Stability Pathfinder RFI Q&A

Updated: 29/08/19 – new questions added at the end: Q102-Q104

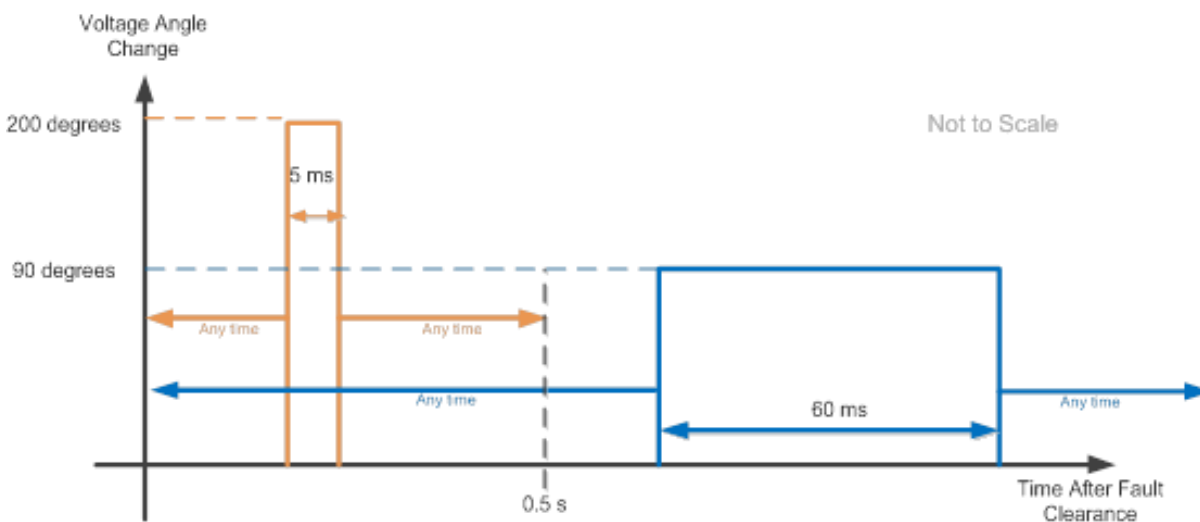
103. In point 1.1.8. of the Technical Performance and Assessment Criteria you mention ride-through post fault voltage angle deviations. Do you have a plot explaining the mentioned effect?
